REGIONAL REVIEW FINDING

ARC REVIEW CODE: R1911081

Name of Proposal: Southern Ready Mix Plant (DRI #3013)

DRI 3013 – SOUTHERN READY-MIX PLANT (STEELE AND PINE VIEW)

SHEET TITLE	CONCEPTUAL SITE PLAN
SHEET	1.0

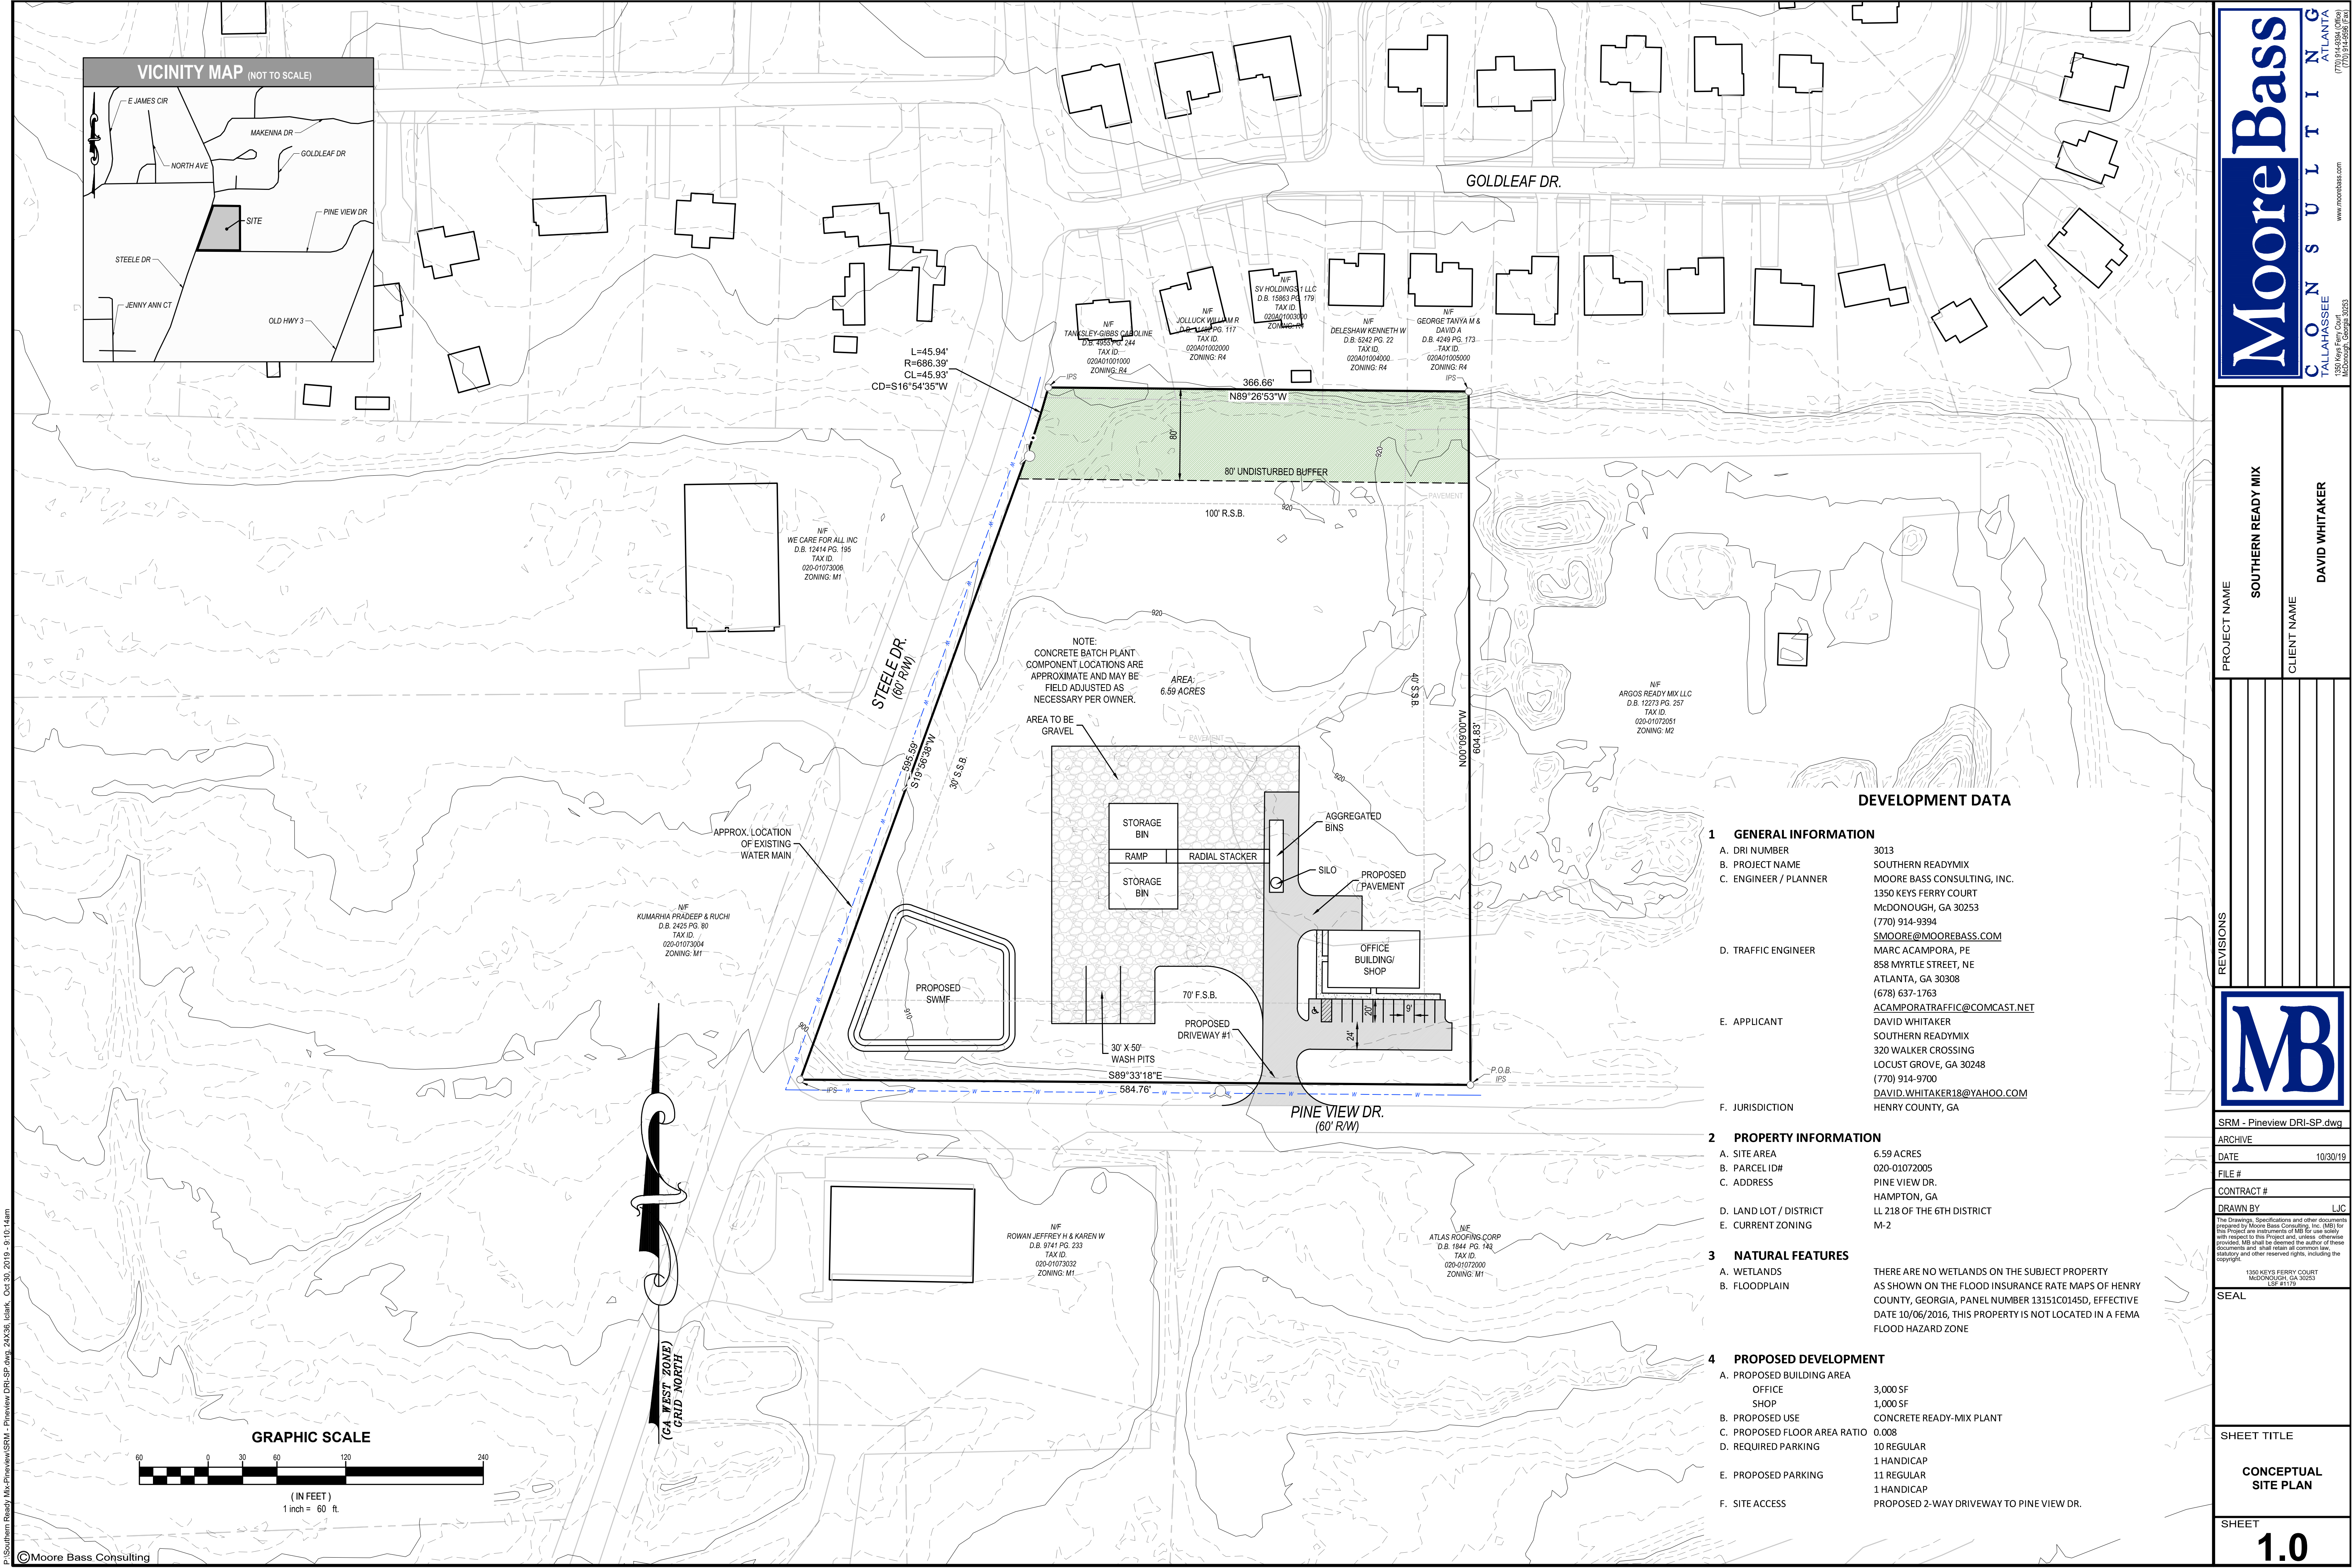
The proposed improvements should consider screening the detention pond at the corner of Steele and Pineview Drive to mitigate the visual impact of the plant service areas i.e. storage bins, silo, gravel pad, and wash pits; in effort to maintain residential character along Steele Drive.
